**REPORT NO. PC-19-084**

**SUBJECT:** EV Ninth & Island (923 Island Avenue) – Appeal of Centre City Development Permit/ Planned Development Permit/Neighborhood Use Permit (CCDP/CCPDP/NUP) No. 2017-30 – East Village Neighborhood of the Downtown Community Plan Area – **PUBLIC HEARING**

**OWNER/  
APPLICANT:** EV Project, LLC, Owner/Applicant

VICINITY ELEVATIONS  
EV 9TH & ISLAND  
DESIGN SUBMITTAL

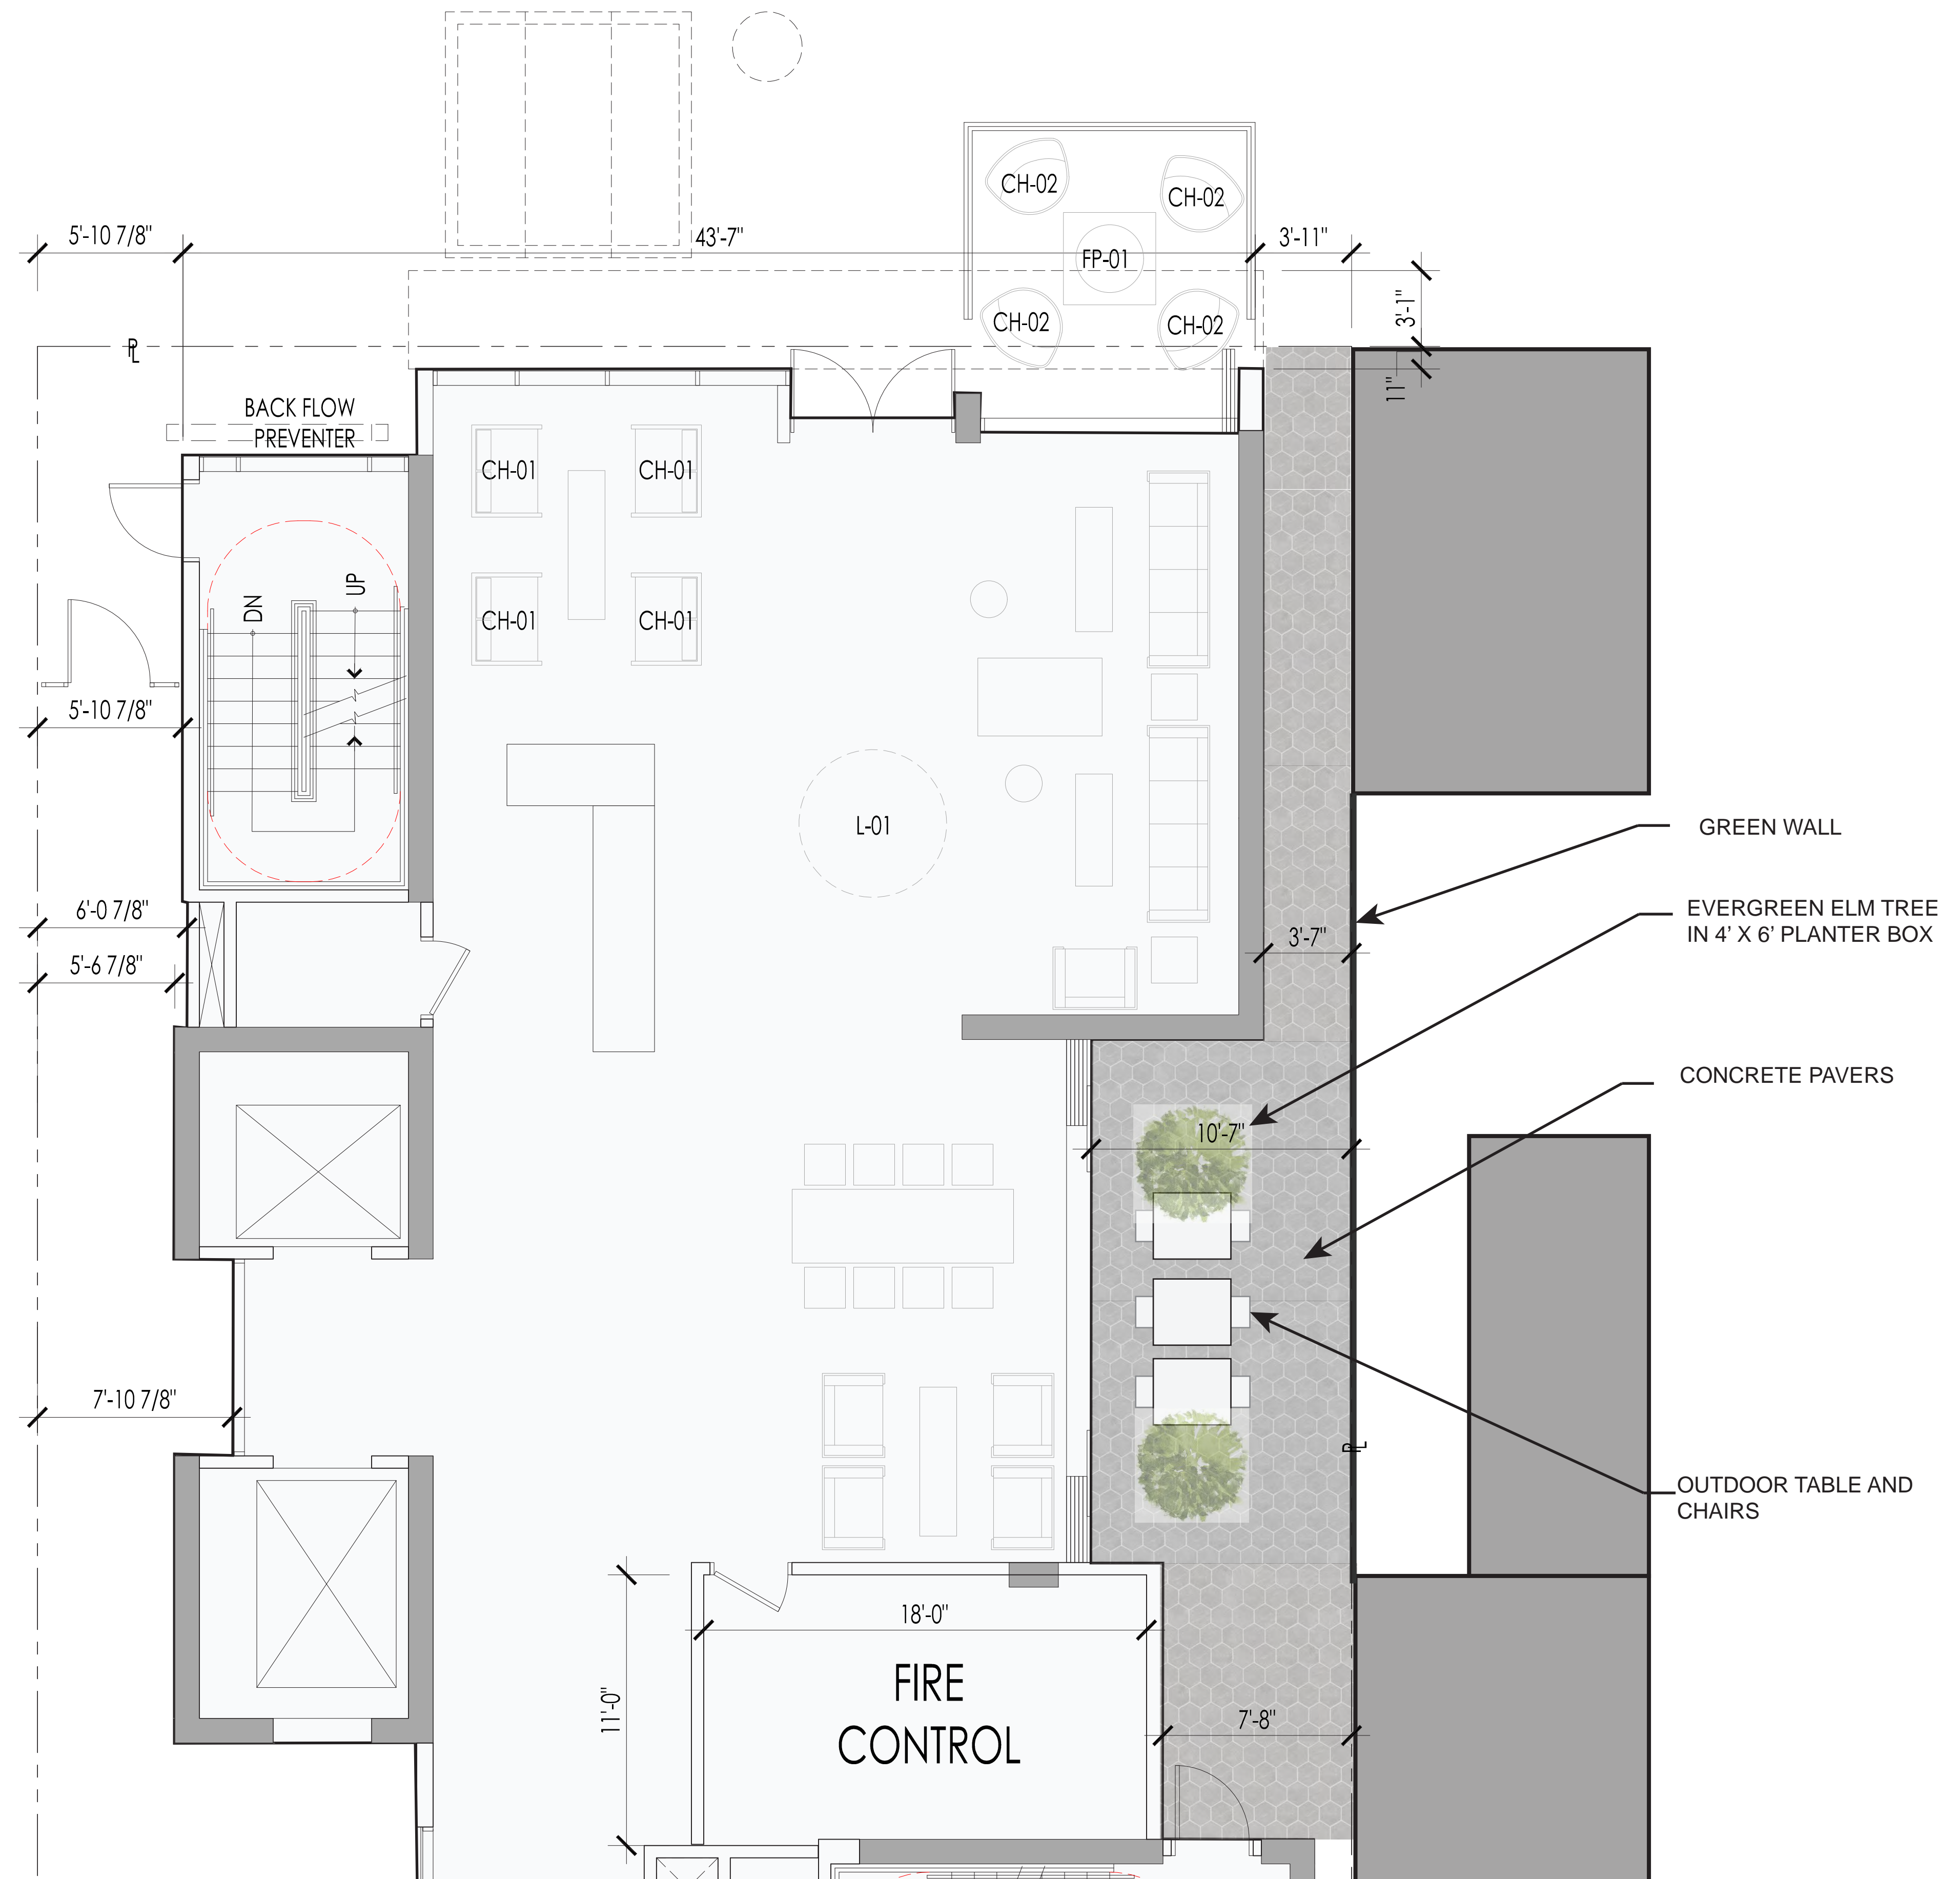
The vicinity elevations on Sheet G.12 of the Basic Concept/Schematic Drawings dated July 24, 2019 (included with the CivicSD staff report, Attachment A) show the Project in relation to other buildings in the immediate area and demonstrate the similar scale. The DCP describes the Ballpark sub-district of the East Village neighborhood as evolving into a mixed-use district with a regional entertainment and cultural focus. The Project advances this goal, maximizes the FAR of the site, and is contextually consistent with other projects that have been developed in this area. Further, the Project preserves the historic Hiatt House on-site in a similar way to The Q development in Little Italy. Both projects feature a small historic building in front of a blank wall that is treated with a pattern and upgraded material to provide visual interest.

## North Facing Perspectives:

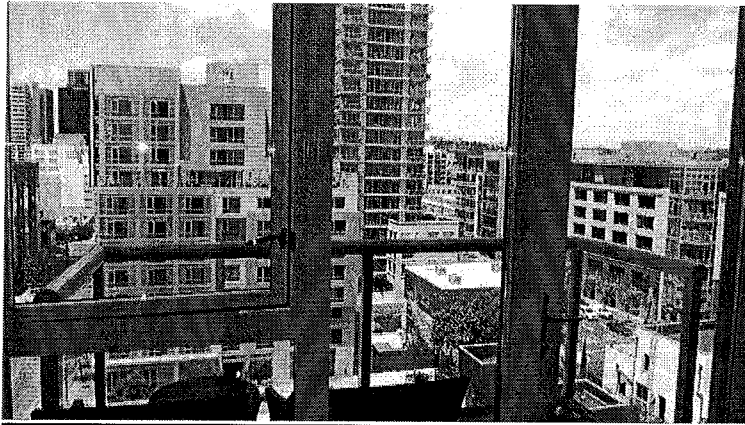
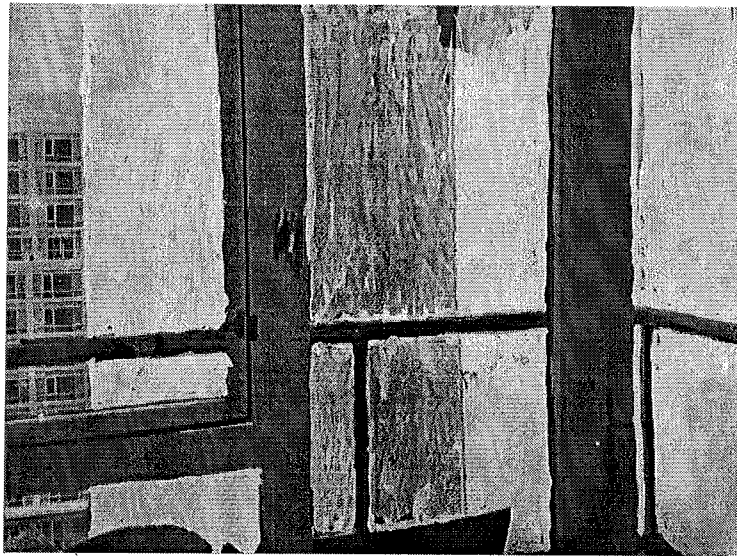
Before and after perspectives towards the proposed Hampton Inn are given below, as viewed looking north from the 10<sup>th</sup> floor of neighboring Diamond Terrace. These perspectives illustrate one instance of how the hotel will have a significant detrimental impact on neighboring properties. Importantly, many owners of north facing units in Diamond Terrace purchased their units with the rightful expectation that their view would be protected by historical and building code regulations governing the adjacent properties to the north.

## Deviant Design – Heightened Blank Wall – SE Perspective

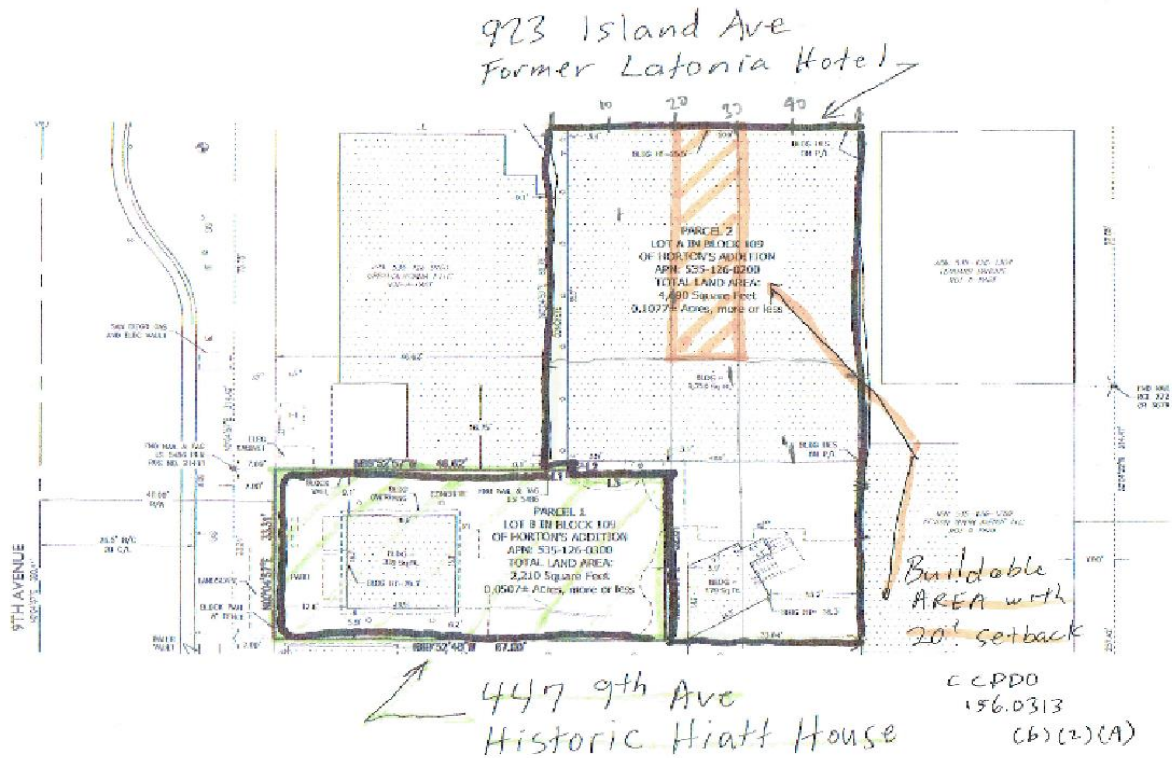
Strictly speaking, if the project were required to rigorously adhere to development regulations, specifically tower setback regulations stated in [SDMC 156.310](#); the parcels would be essentially undevelopable above 85 feet as a mid to high rise project, even assuming the lot tie in agreement provides increased floor area ratio compliance. This is notwithstanding that one of the parcels is historically designated.

SDMC section [156.0310\(d\)\(3\)\(E\)](#) states: *(E) Tower Setback from Interior Property Lines. Towers shall avoid blank walls, allow glazing, and be set back from interior property lines adjoining another parcel by a minimum of 20 feet, subject to the following two exceptions: (i) If the applicant can demonstrate that construction techniques permit glazing with views into, and out from, habitable areas within the tower, this setback may be reduced to 10 feet if any existing tower on an adjacent parcel is located a minimum of 40 feet from the proposed tower; or (ii) If an existing tower on an adjoining parcel contains a blank, solid wall with less than a 20-foot*

## Developable Area when Complying with 20 Foot Tower Setback

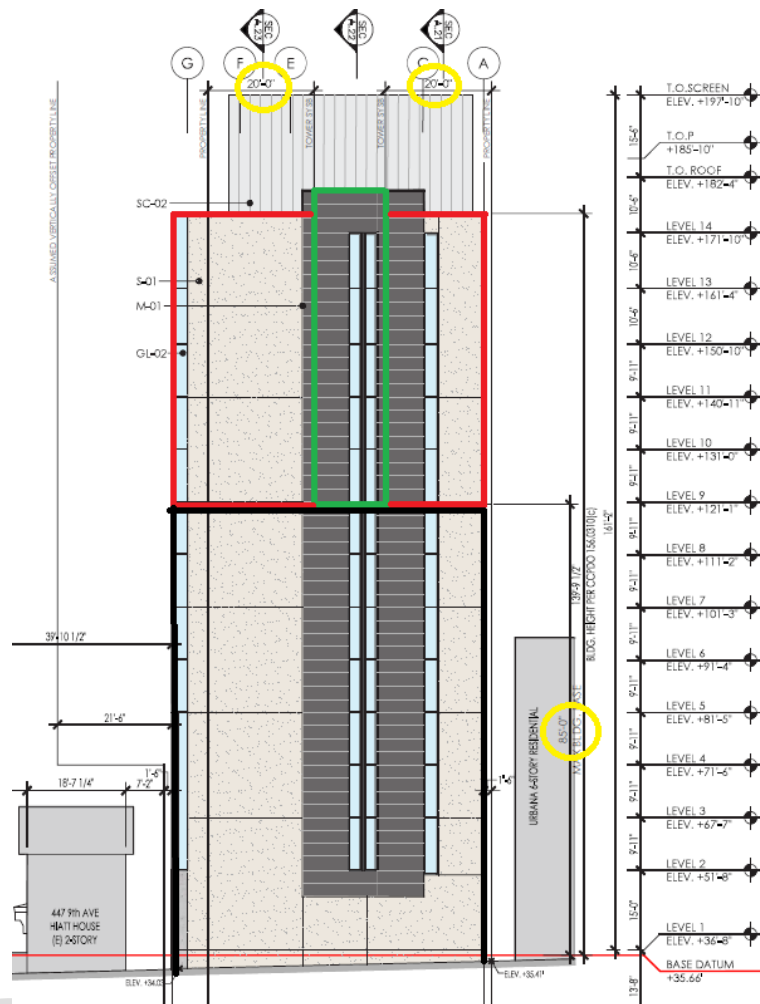
A [back of the envelope](#) sketch figure below depicts in orange the tower area above 85 feet if building codes were strictly adhered to.

The approved project allows reductions of the tower setback from the interior property to no less than 1'6" on the east elevation, 5'-6" on the west elevation, and 3'-3" on the south elevation. This facilitates building the upper stories of the hotel. The diagram below highlights the area above 85 feet that would be buildable if the reductions were not approved. As can be seen by the diagram, for all intents and purposes, the tower would be limited to 85 feet in height.
